SUMMARY OF ITEMS OF STANDARD MANUFACTURE REQUIRED FOR REVISION PER ECU 016
PURCHASE OF ALL ITEMS BY FIELD

AUXILIARY BUILDING UNITS 1 & 2	
125 TON CRANE	
LIMIT SWITCH ARRANGEMENT	
SEQUOYAH NUCLEAR PLANT	
TENNESSEE VALLEY AUTHORITY	
DIVISION OF ENGINEERING	
SUBMITTED	RECOMMENDED
APPROVED	APPROVED
KNOXVILLE	45

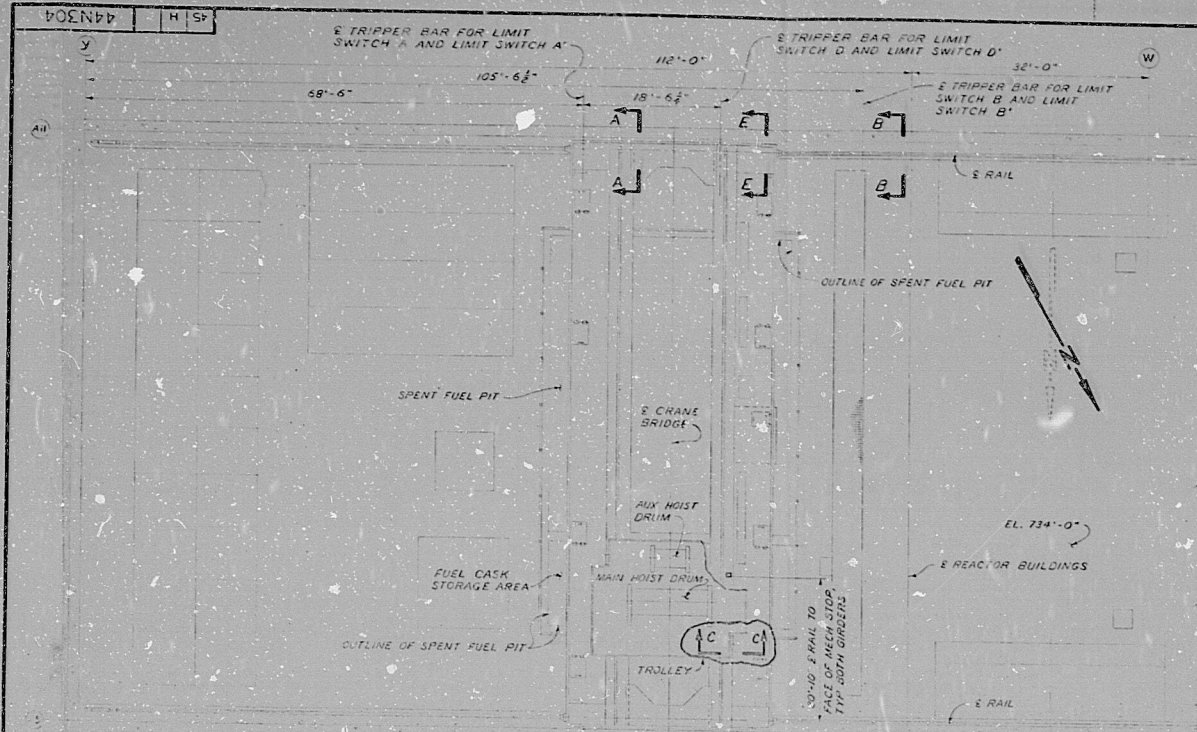
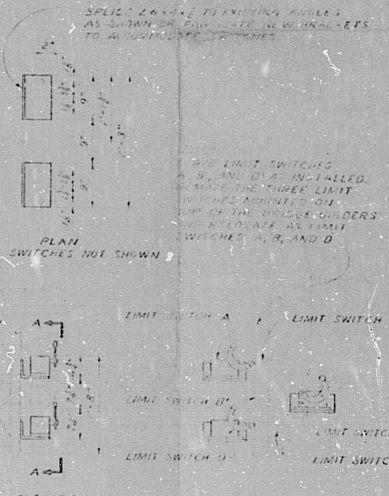
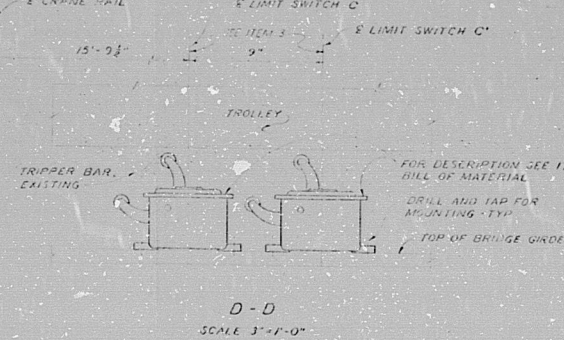
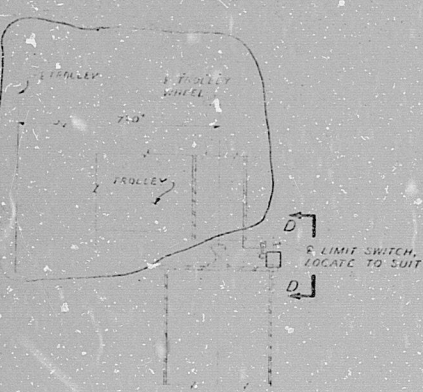
FIELD NOTE: FIELD REVISIONS REQUIRED PER ECU 016 INVOLVE REVISIONS AS SHOWN ON THE PLOTTING DRAWINGS.

THE REVISED LIMIT SWITCH ARRANGEMENT PER ECU 016 IS REQUIRED TO MEET ADDITIONAL AEC REQUIREMENTS. THE ADDITIONAL REQUIREMENTS WERE ESTABLISHED AT THE COMPLETION AND DELIVERY OF THE CRANES BY THE CONTRACTOR.
